**RE: City of Decatur WWTP Inspection (Benton Co)**

**AFIN: 04-00052**

**NPDES Permit No.: AR0022292**

**Office of Water Quality Photographic Evidence Sheet**

Location:	<b>City of Decatur WWTP</b>		
Photographer:	<b>Garrett Grimes, District 1 Inspector</b>	Date:	<b>4/14/2023</b>
Witness:		Time:	<b>9:55</b>
		Photo #:	<b>3</b>
Description:	<b>Continued from Photo #1.</b>

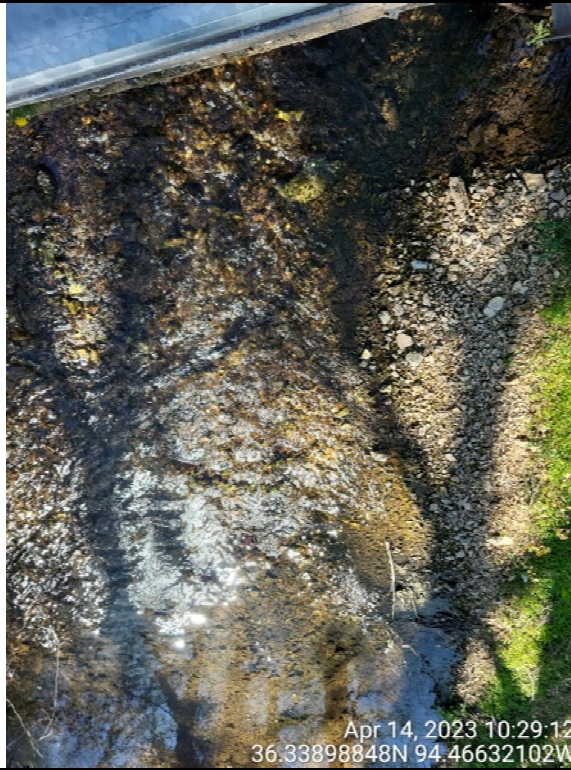
**	SAMPLING	**	SLUDGE HANDLING/DISPOSAL	**	PRETREATMENT
**	OTHER:				
<b>SUMMARY OF FINDINGS</b>					
<p>The following violation was noted during the inspection:</p> <p>There has been an unpermitted discharge of wastewater treatment residuals (i.e., sludge) from the treatment plant. This is a violation of Part 1, A of the permit.</p>					
<b>GENERAL COMMENTS</b>					
<p>On April 14, 2023, I performed a reconnaissance inspection in response to a complaint alleging solids associated with wastewater treatment accumulating downstream of the City of Decatur WWTP. I observed treatment residuals accumulating near a bridge over Columbia Hollow Creek downstream of the treatment plant (Photos #1 - #4; Attachment 1). These were not observed upstream of the treatment plant (Photos #5 - #6; Attachment 1). I was unable to access the plant directly during the inspection due to the facility being closed and personnel absent, but a voicemail was left with the number posted at the facility with my contact information and reason for the site visit.</p> <p>Following my departure from the permitted area, I was contacted by James Boston with the City of Decatur. I explained my observations to Mr. Boston and he stated that the city was aware of a release that occurred due to a hydraulic overload during a heavy storm resulting in partially treated wastewater overflowing the plant and entering the receiving stream. Mr. Boston stated that this was reported electronically to the DEQ - Office of Water Quality - Enforcement Branch (Attachment 2). Previous observations of overflows at the City of Decatur WWTP have been referred to the Enforcement Branch and the City of Decatur is considering upgrades to the treatment plant in order to adequately address the flows received at the facility. Details from this inspection will be forwarded to the Enforcement Branch for further review.</p>

Location:	<b>City of Decatur WWTP</b>		
Photographer:	<b>Garrett Grimes, District 1 Inspector</b>	Date:	<b>4/14/2023</b>
Witness:		Time:	<b>9:52</b>
		Photo #:	<b>1</b>
Description:	<b>Wastewater treatment residuals accumulating adjacent to Columbia Hollow Creek downstream of the Decatur Wastewater Treatment Plant.</b>
